**M54 to M6 Link Road
TR010054**

**8.8 LA(A) Statement of Common
Ground with Staffordshire County
Council**

STATEMENT OF COMMON GROUND

This Statement of Common Ground has been prepared and agreed by (1) Highways England Company Limited and (2) Staffordshire County Council.

Drawing Title
HIGHWAYS MAINTENANCE BOUNDARY

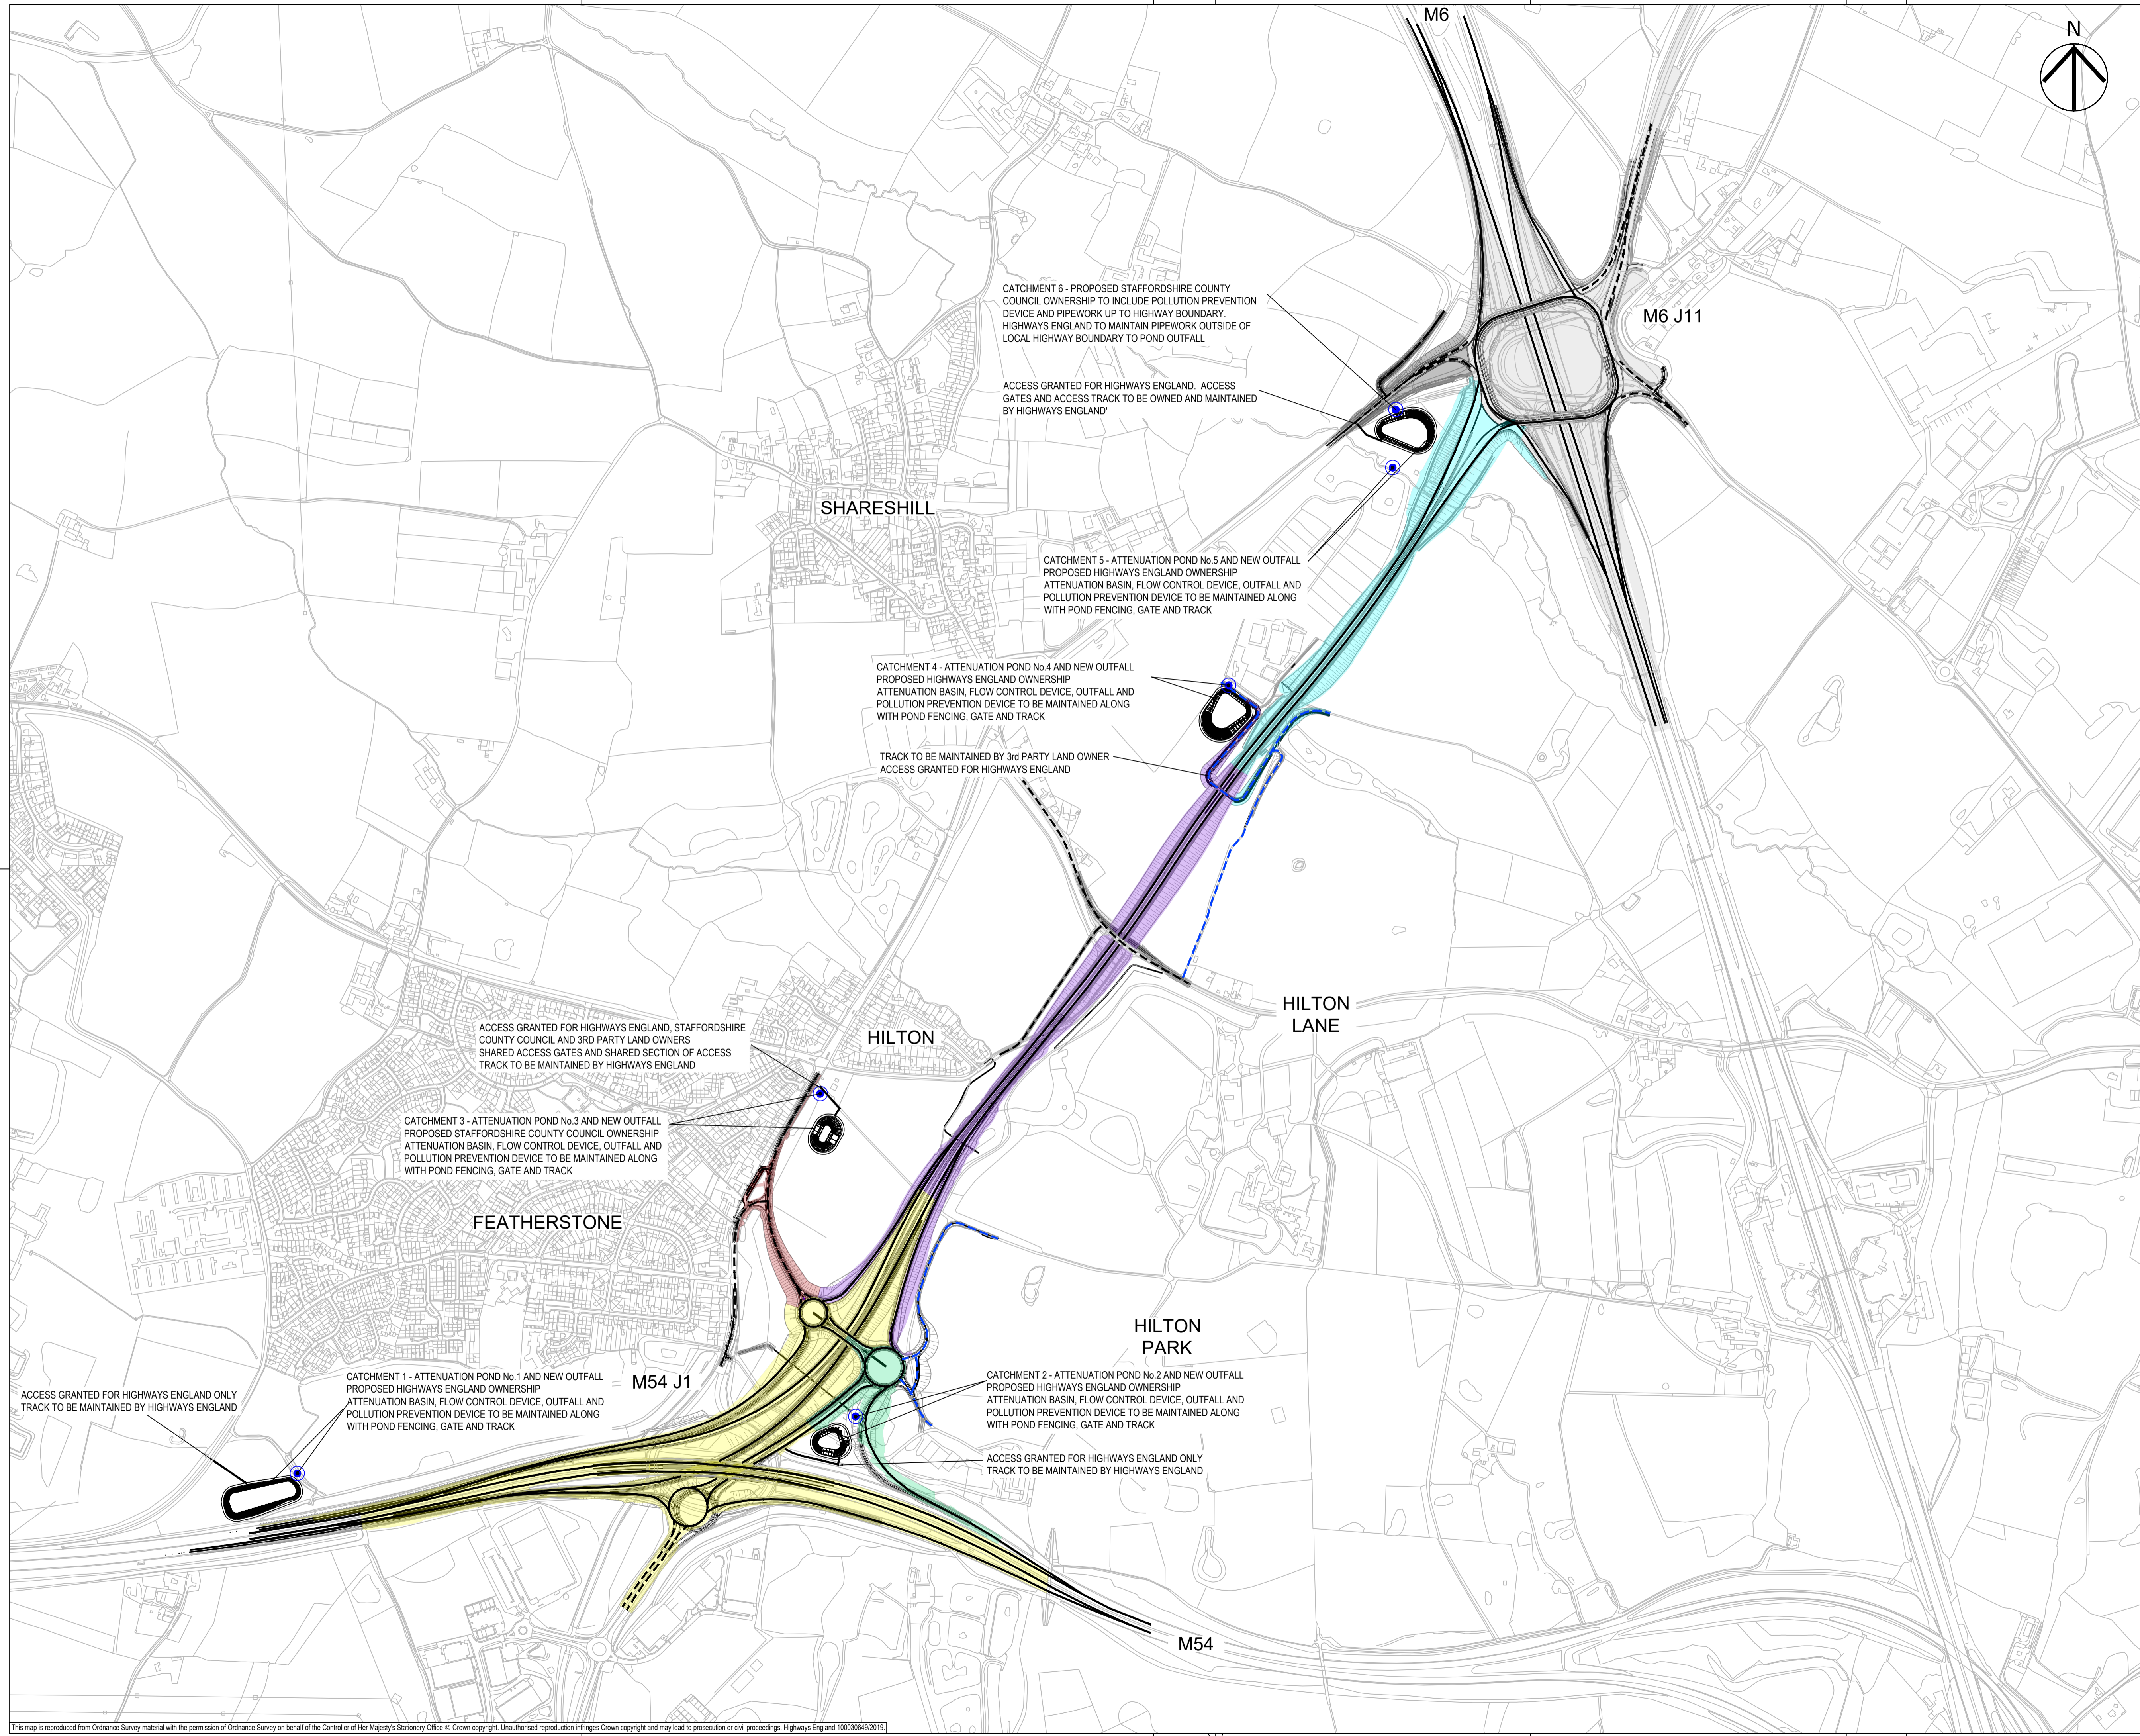
<p>Maintenance Boundary Drawing: HE514465-ACM-HGN-M54_SW_PR_Z-DR-CH-1009 (Rev P03) Not submitted with the DCO application</p>	Maintenance Boundaries	<p>Discussions have been ongoing with SCC on proposed future maintenance boundaries after construction. Initial plans showing proposed boundaries were shared with SCC at a meeting in November 2019 and by e-mail from AM on 18 December 2020 (drawing HE514465-ACM-HGN-M54_SW_PR_Z-DR-CH-1009). The areas of the Scheme proposed to be maintained by SCC are the A460 south and North of M54 Junction 1, Hilton Lane, Cannock Road, A460 North and A462 at M6 Junction 11. All other areas of the Scheme are proposed to be maintained by HE.</p> <p>Previously the links between the Featherstone Junction West Roundabout, Featherstone Junction East Roundabout and M54 Junction 1 South Roundabout were proposed to be maintained by SCC. SCC requested a</p>	Agreed	Agreed

<p>change to maintenance boundaries at M54 J1 so that HE would maintain the internal connecting roads and three roundabouts rather than SCC. HE agreed to this change.</p> <p>An updated plan was provided to SCC on the 10 March 2021 indicating the revised responsibilities for the maintenance of the drainage network and attenuation requirements south of M6 Junction 11 (see below) and the location of the pollution control device on SCCs drainage network within the highways boundary upstream of the outfall to the attenuation basin.</p> <p>The parties have also agreed that:</p> <ul style="list-style-type: none"> • HE will maintain the attenuation pond at M6 Junction 11 with SCC having a pollution device on their network. Therefore, no commuted sum or similar is required for the maintenance of the pond. • There is only one sign on SCC's network outside the Order limits that will require amendment following construction of the Scheme, in addition to signage for the speed limit change at Hilton Lane. Works are limited to the removal or masking of 'A460' on one sign. The parties agree that the simplest solution would be for SCC to change the sign and HE to reimburse reasonable costs. • Subject to SCC confirming the amount and providing a breakdown for HE's approval, it is agreed in principle that HE will provide a commuted sum to SCC to cover SCC's reasonable costs associated with the maintenance of the additional area around the A460 tie in at Featherstone. <p>Following amendments made at SSC's request the parties have largely agreed future maintenance responsibilities as set out in the specified plan with the exception of the pond discussed below. Revision P04 of the Maintenance Boundary drawing shows the agreed position in principle (see Appendix .</p> <p>Highways England will provide a plan that is easy to digitise showing the precise areas to be maintained by SCC during or following completion of detailed design.</p>
